RE: Pinnacle at Liberty Bay - P-06-20-25-03 - Retaining Wall Design & Maintenance and Landscaping Coordination Response

ESM Consulting Engineers, LLC submits this narrative in response to the City's Request for Revisions No. 5, as well as the related public comments regarding retaining wall stability, long-term maintenance, neighborhood visual impact, and landscape coordination and treatment adjacent to retaining walls. To ensure compatibility with the existing single-family residential environment, the grading and wall plan has been heavily revised, entirely eliminating the previously proposed 35-foot retaining walls.

Encl. Figure 1

PROPOSED WALL CROSS SECTIONS

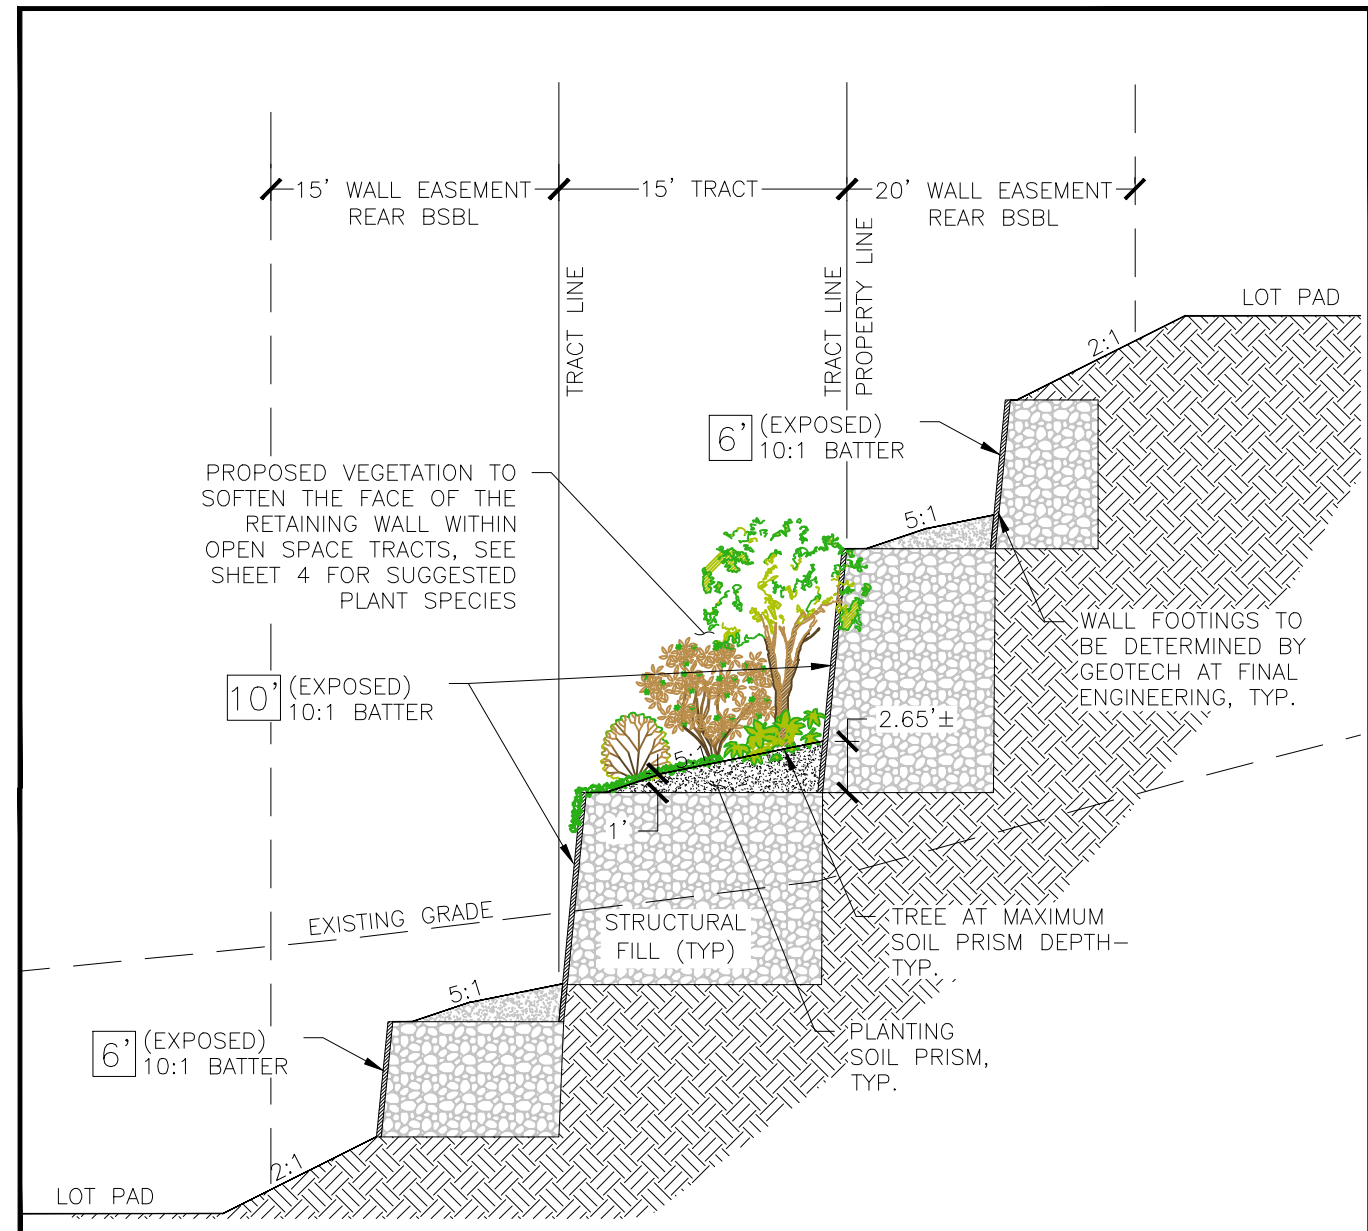
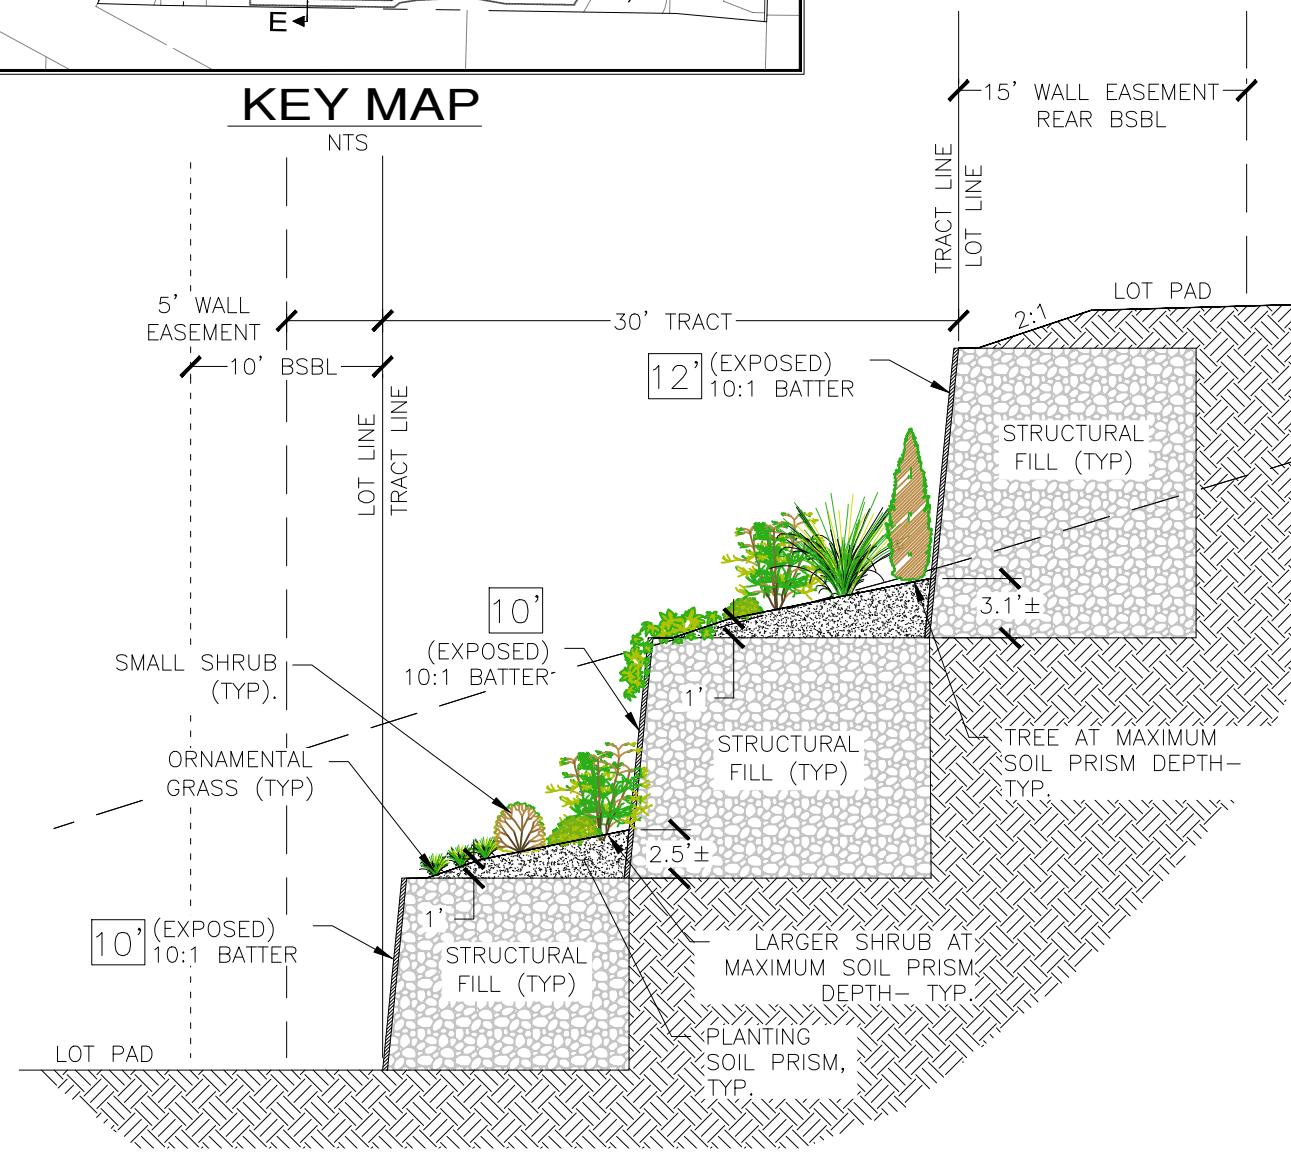
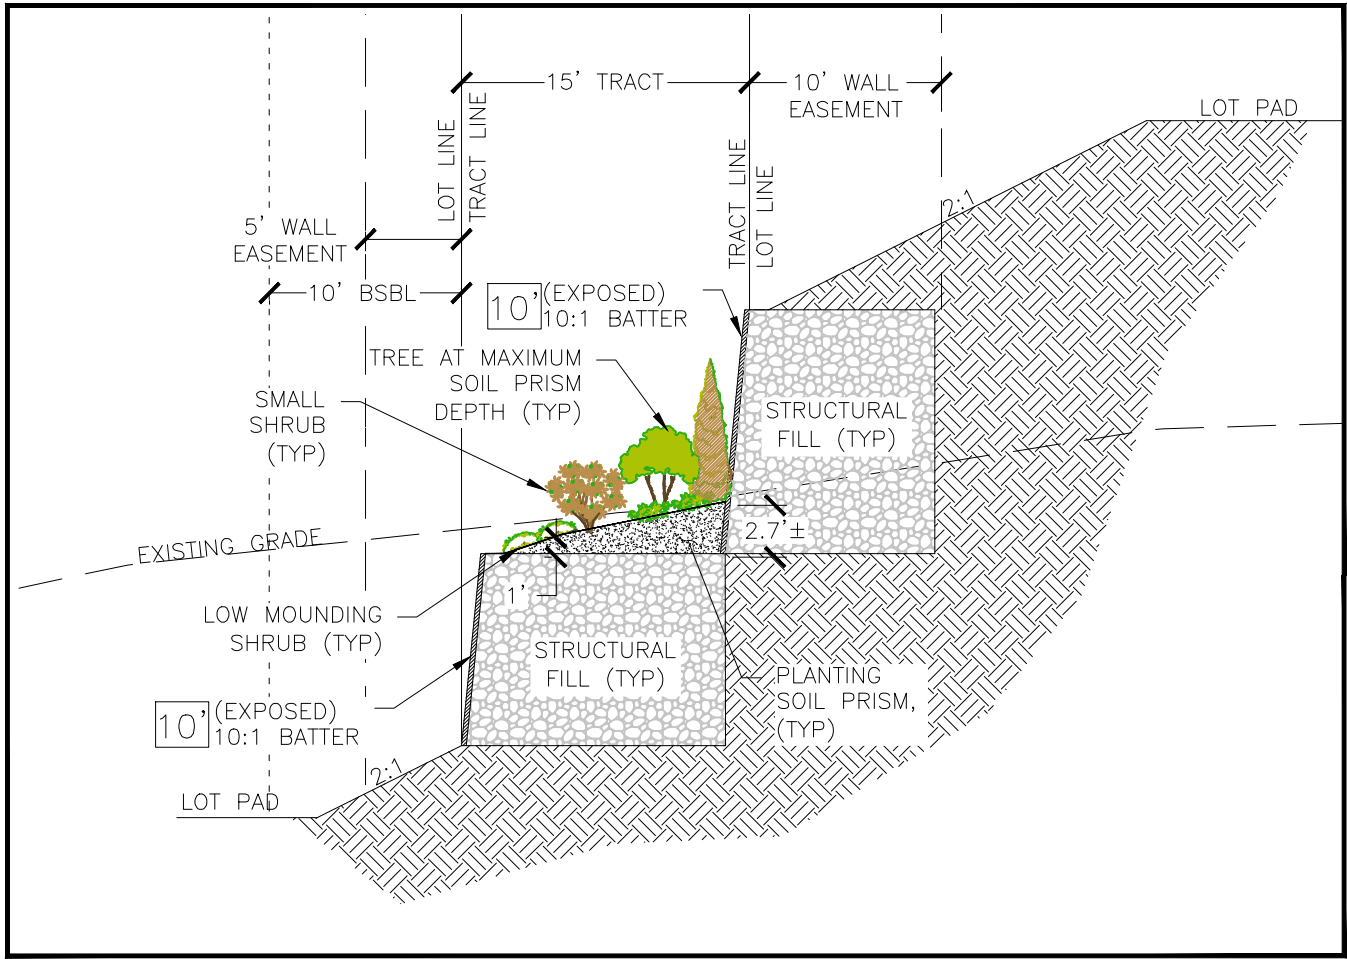
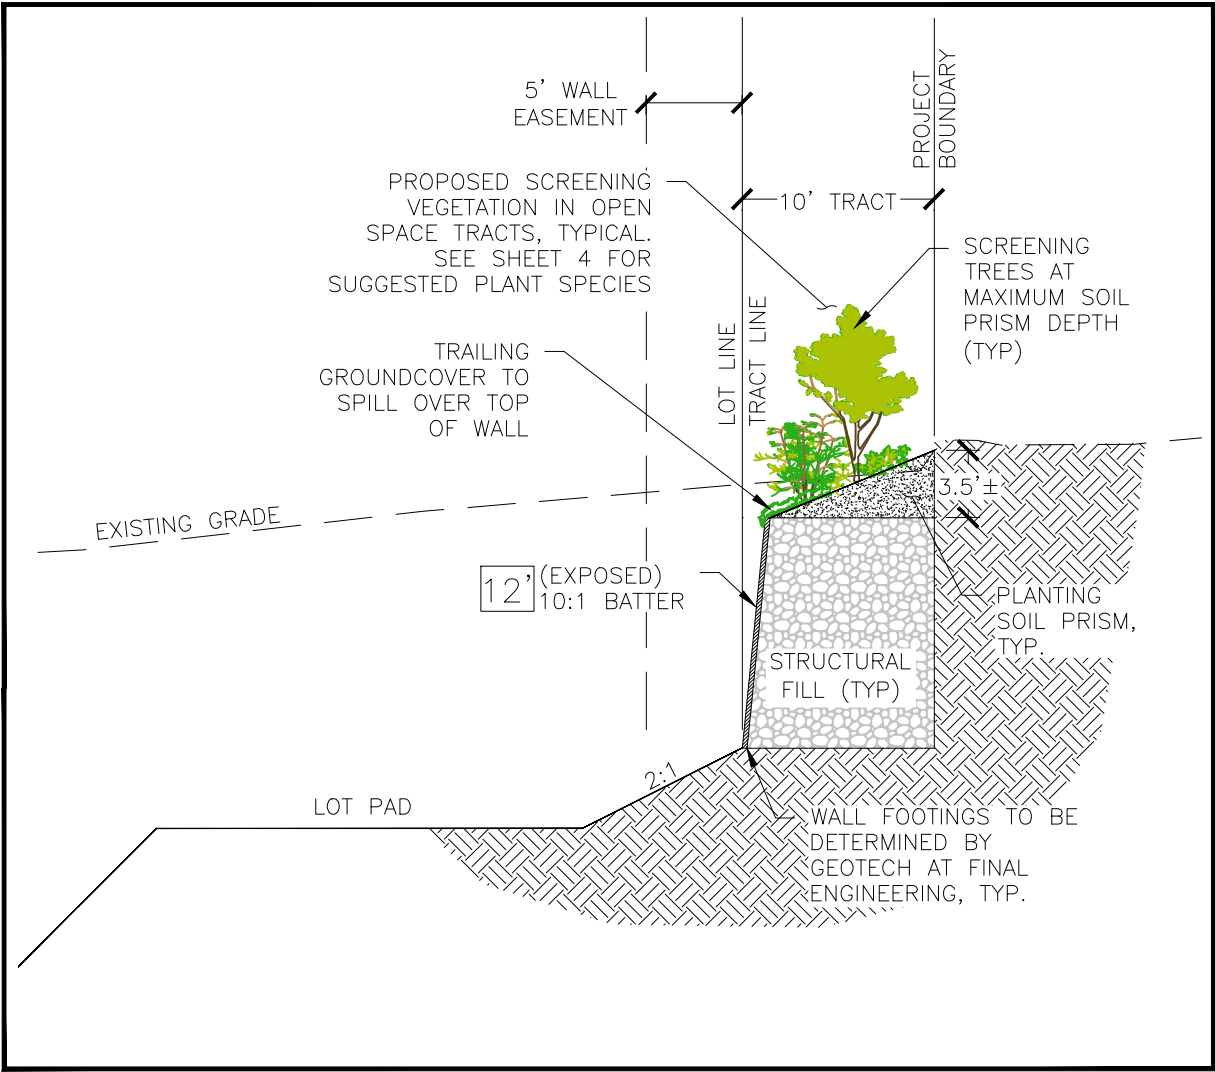
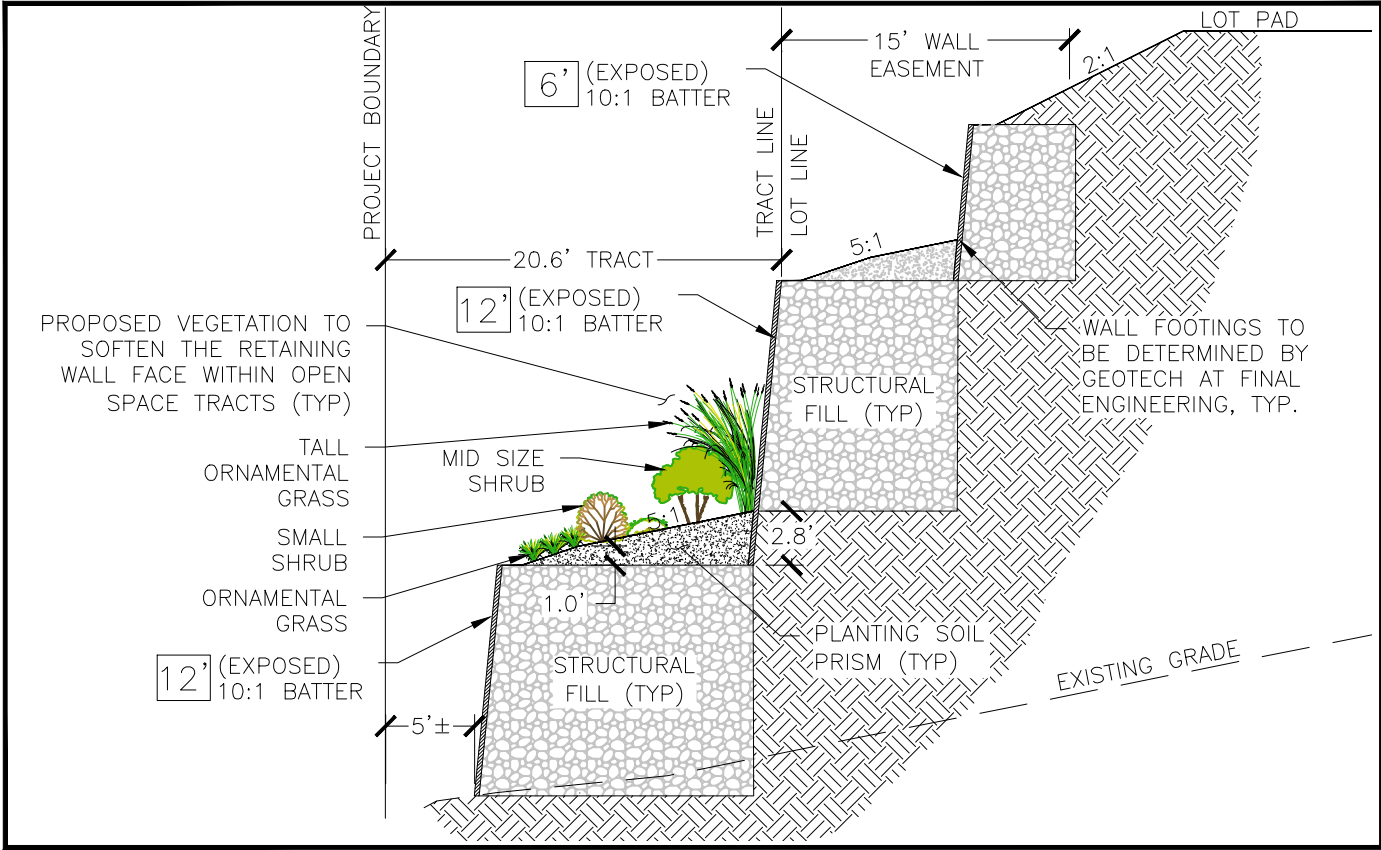
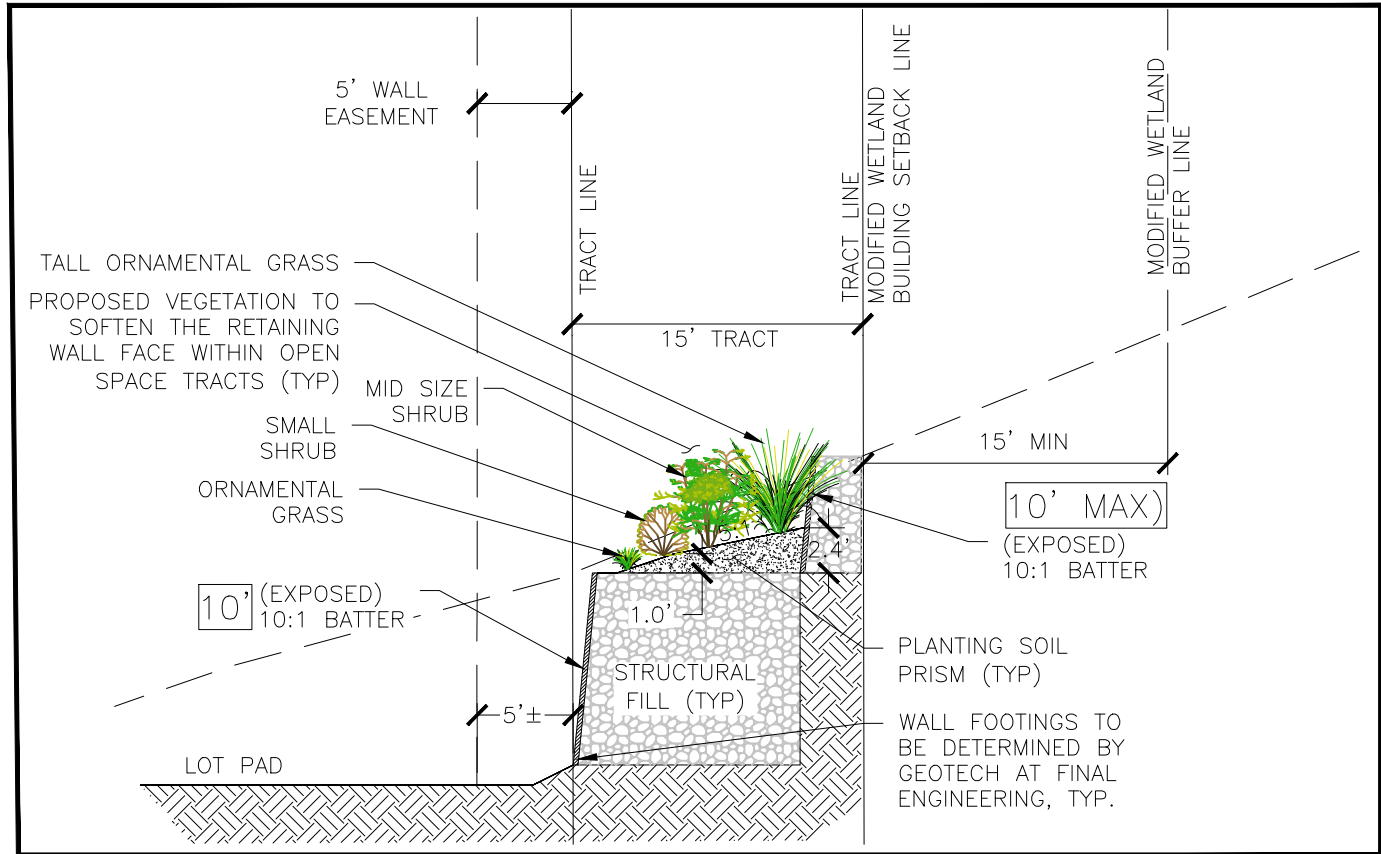
The Landscape and Open Space Plan has been revised to coordinate proposed landscaping with the preliminary retaining wall, grading, utility, and stormwater plans. Encl. 1 identifies the landscape areas in relation to the retaining walls and associated wall tracts and includes cross section views of the tiered wall areas.

At the tiered wall areas, Encl. Figure 1 shows the planting space available between wall tiers. Planting will only be installed where there is adequate room for the proposed material, including proper soil volume and separation from the wall structure and drainage system.

Landscaping has been provided next to retaining walls where space allows, as shown on Encl. Figure 1. The intent is to break up and soften the appearance of exposed wall faces while maintaining space needed for the retaining walls, utilities, drainage, and maintenance access.

The sections on Encl. Figure 1 show that planting between retaining wall tiers can be accommodated and maintained where adequate planting space and soil volume are available. Planting will not be placed within wall foundation areas, drainage aggregate zones, subdrain areas, or required maintenance areas.

JOB NO. 2090-004-022
DRAWN: LDK
DATE: 2026-09-02
SHEET 4 OF 4

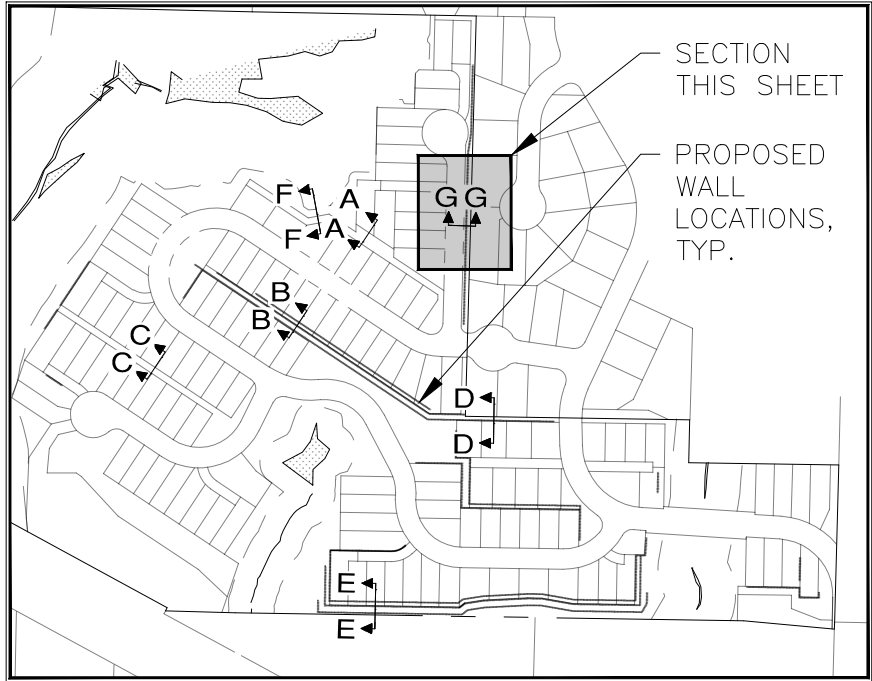
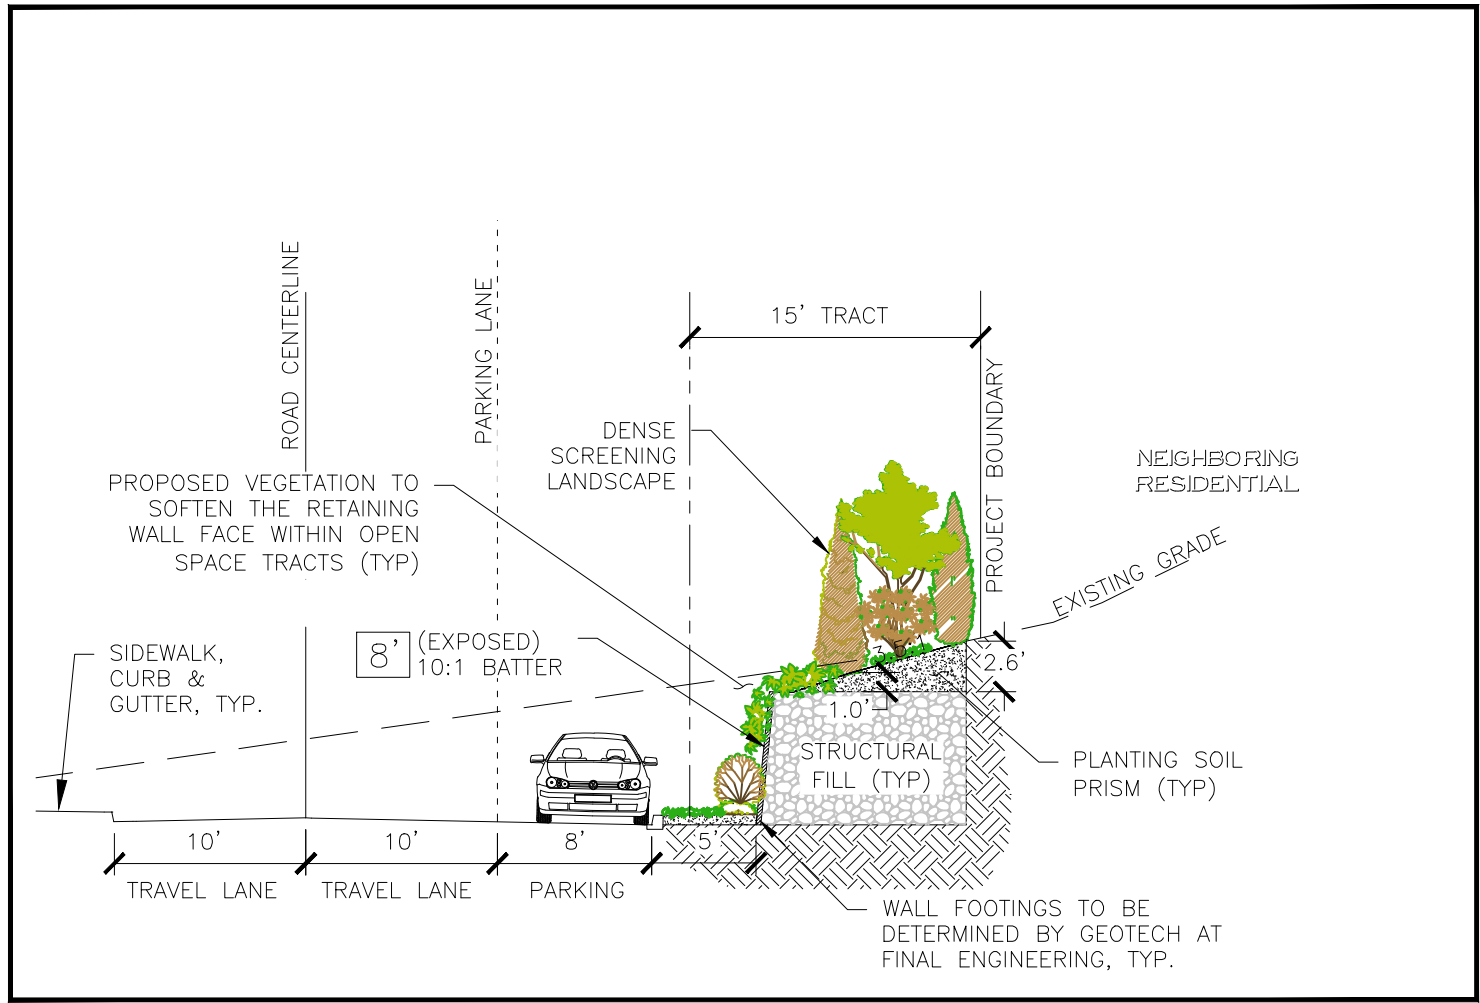
- **Road B Parking Adjacent to walls:** Parallel parking stalls are proposed along the east side of Road B adjacent to a proposed retaining cut wall. As detailed on Sheet 4 of the Encl. Figure 1, the retaining wall proposed along Road B provides a sufficient horizontal separation distance of 5 feet between the parallel parking stalls and the adjacent wall face. A vertical curb is incorporated directly along the parking edge and will prevent vehicles from parking closer than 5 feet from the wall.
- **Critical Areas:** In compliance with critical area criteria (PMC 16.20.230 and PMC 16.20.315), the proposed wall system minimizes the horizontal footprint, ensuring that neither the exposed wall faces encroach into the required 15-foot wetland building setback nor the 25-foot stream building setback. Enclosed cross-sections visually demonstrate this relationship.
